Product hierarchy no. *				Part no.	SBU	Type / Description	Customer part no.
SBU	PG	PUG	Type				
90	004	004	0000001008		Voltage Selector	SWM1 (Frontpl)

The locknut and the socket of the SWM voltage sector changes to a M20x1.5 thread (previous M20x1).

Product Change Notification					SWM nut change second step		
owner	creation date	release date	released by	change order no	rev	page	D10-056-473
zeierjo	08.04.2021	21.09.2021	haeckima	2021508	A	1 of 2

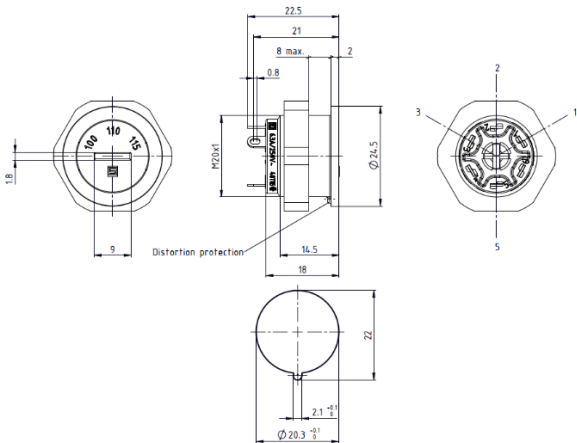
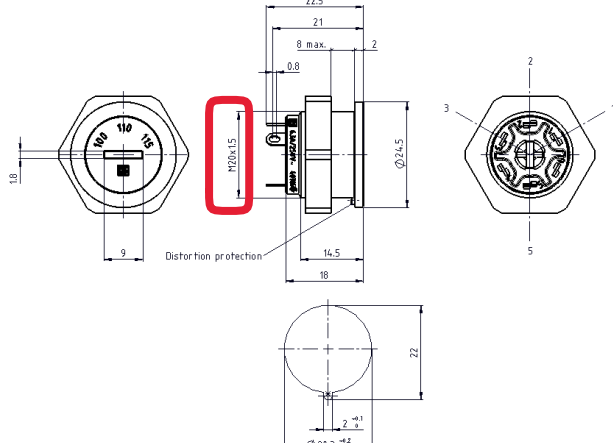
Old product dimensions	New product dimensions
 Hexagonal locknut M20x1, socket M20x1	 Hexagonal locknut M20x1.5, socket M20x1.5
Old packaging	New packaging
 Cardboard box 178x91x71, quantity 50 pcs	 Cardboard box 200x170x85, quantity 100 pcs
